Re: Comments on Environmental Assessment for Scotts Valley Casino and  
Tribal Housing Project

This letter and its attachments and enclosures provide comments from the Yocha Dehe Wintun Nation on the Environmental Assessment ("EA") prepared for the Scotts Valley Casino and Tribal Housing Project ("Project").

**DETAIL A**  
**WEST-EAST CROSS SECTION**  
**THRU PROPOSED UTILITY YARD**  
 FOR  
**SCOTTS VALLEY**

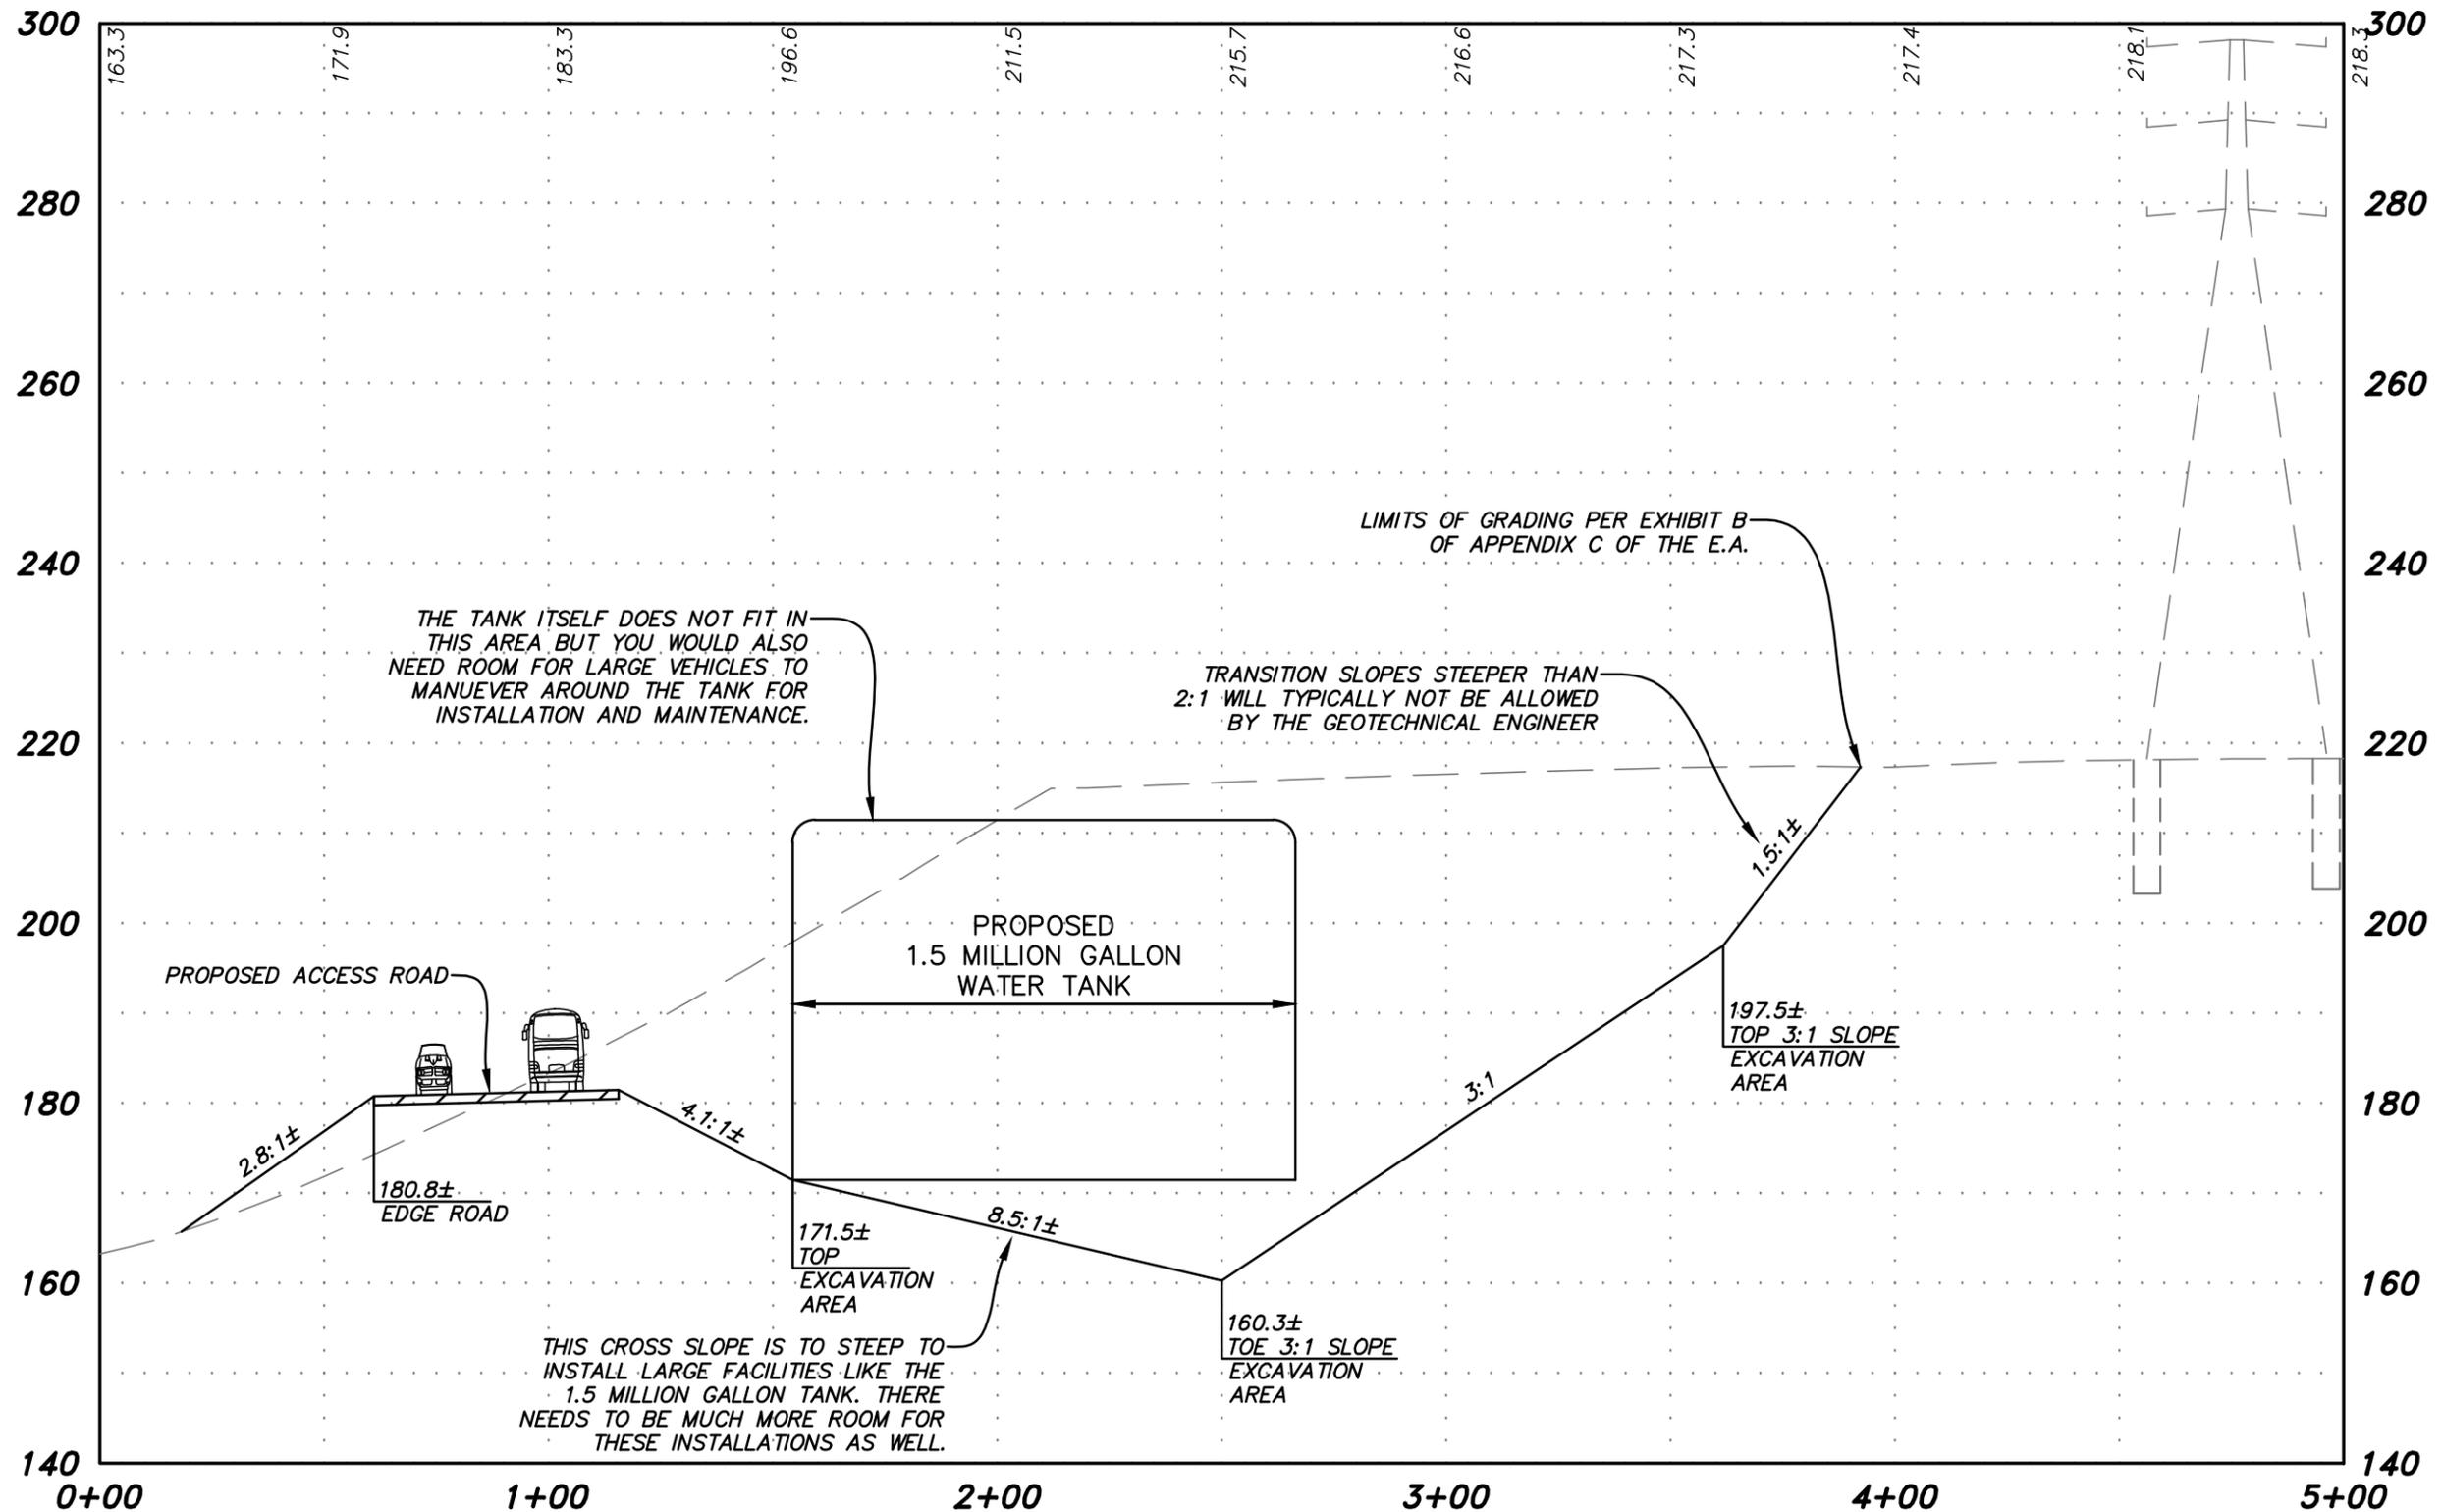
- Both of the Project’s water supply options require construction of a 1.5-million-gallon potable water tank (with a 112-foot diameter) within the 3.5-acre “utility area” in the southwest corner of the Project site. But the grading plan does not provide any flat area where such a tank could be located. Indeed, the utility area appears to have just 1.7 acres that are not within a 3:1 slope.

- In addition to massive water tanks, the EA contemplates that the utility area would contain backup generators and control equipment – and may also accommodate a potable water treatment plant, a wastewater treatment plant, large recycled water tanks, a police station, a fire station, and/or drinking water wells (depending on different water, wastewater, and public safety options). No reasonable person would believe all of this could be accommodated in a single 3.5-acre site (where, again, just 1.7 acres has less than 3:1 slope). Moreover, the grading plan suggests the “utility area” would be roughly 10 feet below the access road – with no clear provision for a connection between the two. How, specifically, does Scotts Valley plan for vehicles to enter or exit a utility area that is 10 feet beneath the access road?

**DETAIL B**  
**WEST-EAST CROSS SECTION**  
**THRU LOADING DOCK AT PG&E TOWER**  
 FOR  
**SCOTTS VALLEY**

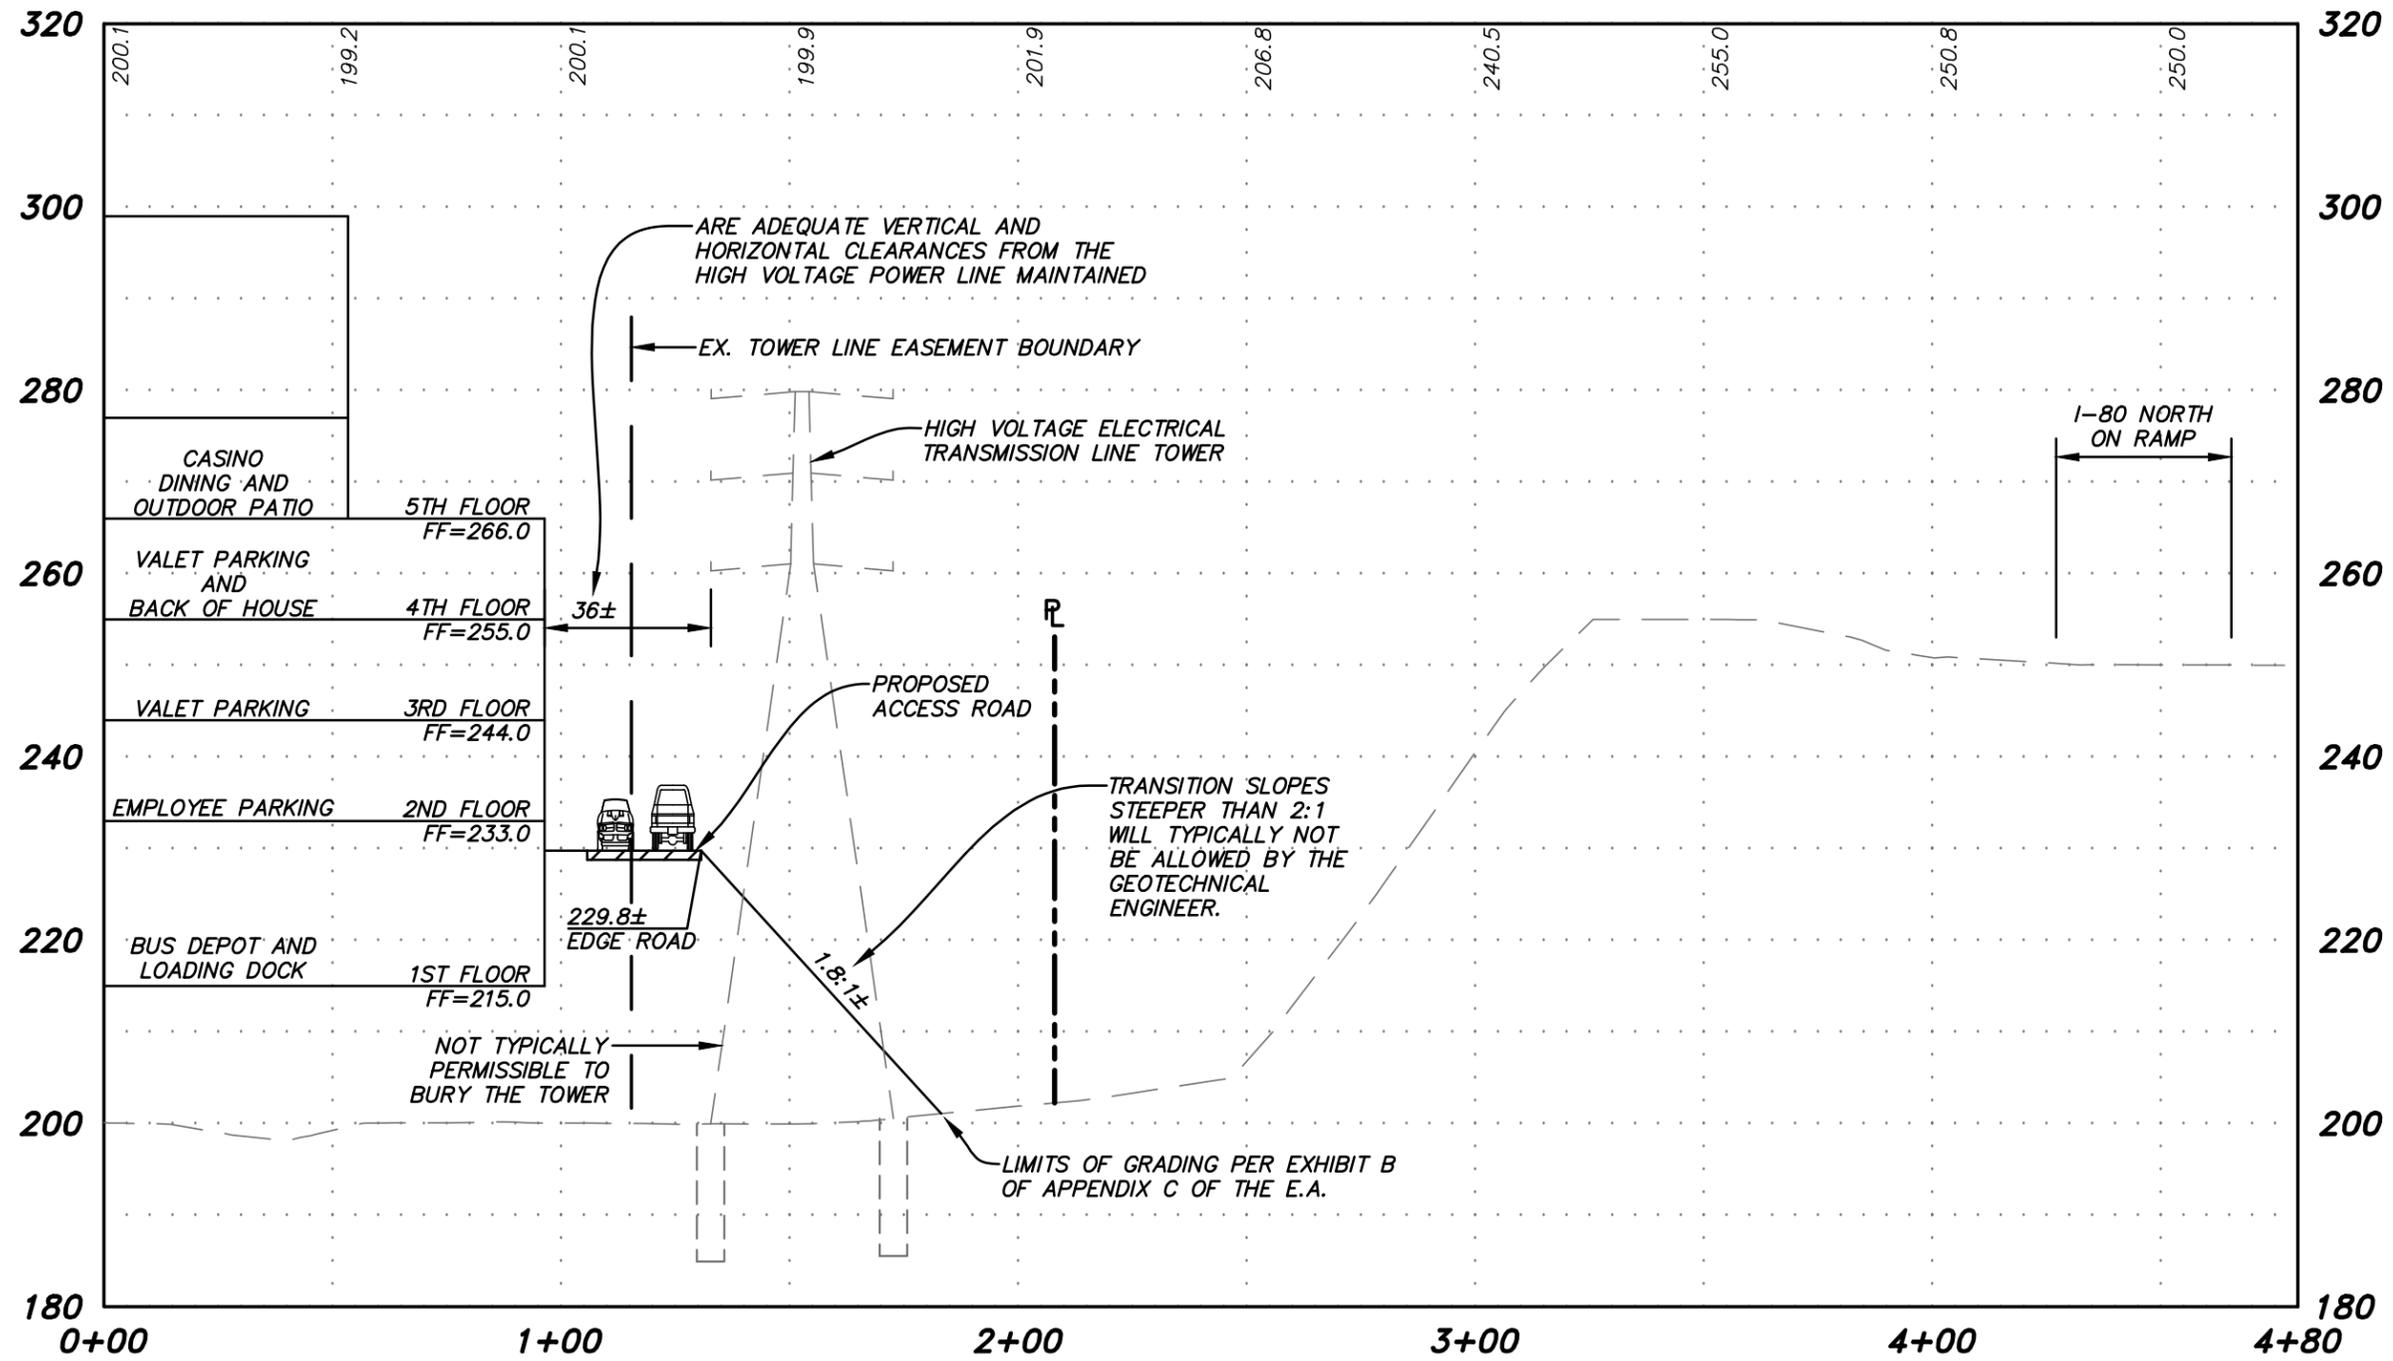
- The Project calls for construction of a 600,000 square-foot casino structure immediately abutting existing high-voltage transmission lines mounted on 80-foot steel towers.
  - To build the casino (and its adjacent access road), the grading plan calls for a 1.8:1 fill slope (substandard for engineering purposes) that would encroach on the transmission line easement and bury one of the transmission towers to a depth of more than 20 feet.
  - The grading plan also reduces the horizontal (to the casino structure) and vertical (to the adjacent access road) clearances between the Project and the transmission lines to dangerous levels.

**DETAIL C**  
**CROSS SECTION THRU**  
**EXISTING WATER TANK**  
 FOR  
**SCOTTS VALLEY**

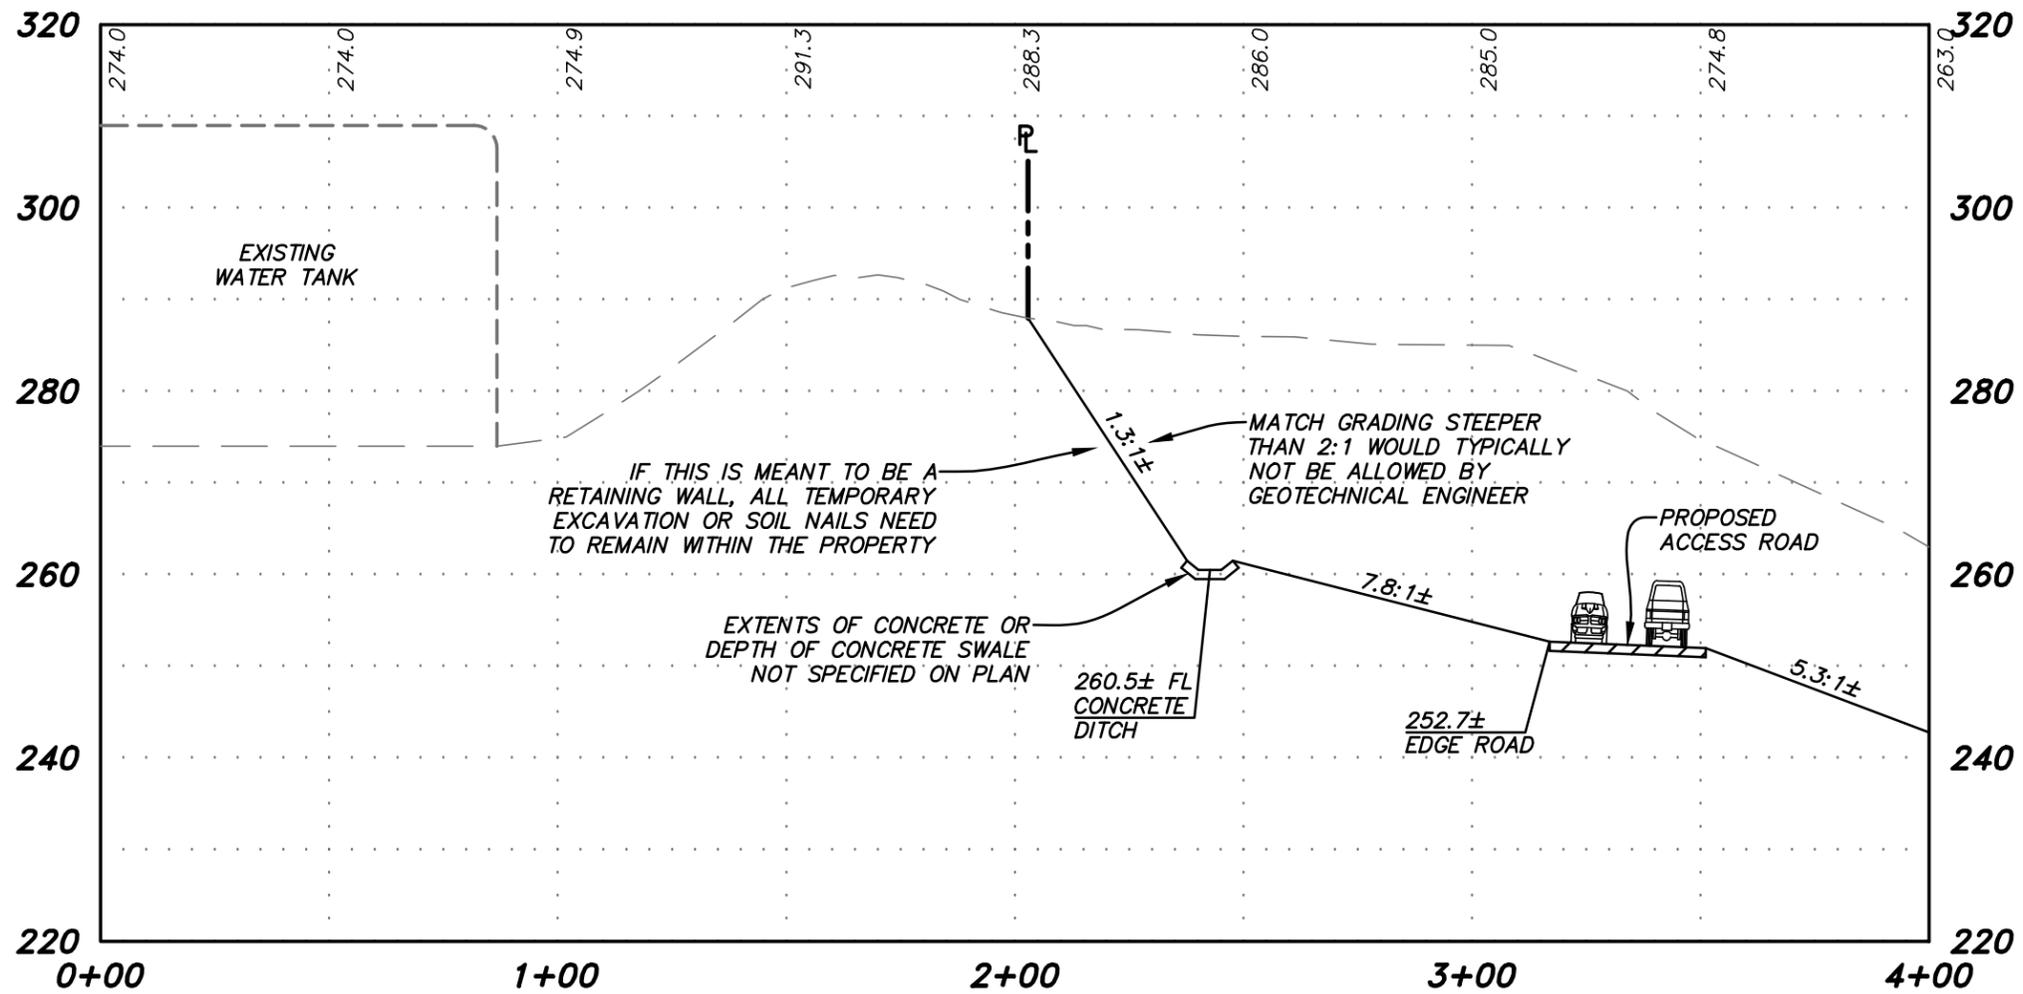
- On the eastern edge of the Project site, the grading plan shows transition grading of more than 30 feet in close proximity to the City of Vallejo’s water storage tank. The EA provides no slope stability design nor any information about a retaining wall, raising very significant safety concerns. Needless to say, destabilizing the City’s water tank would have serious consequences.
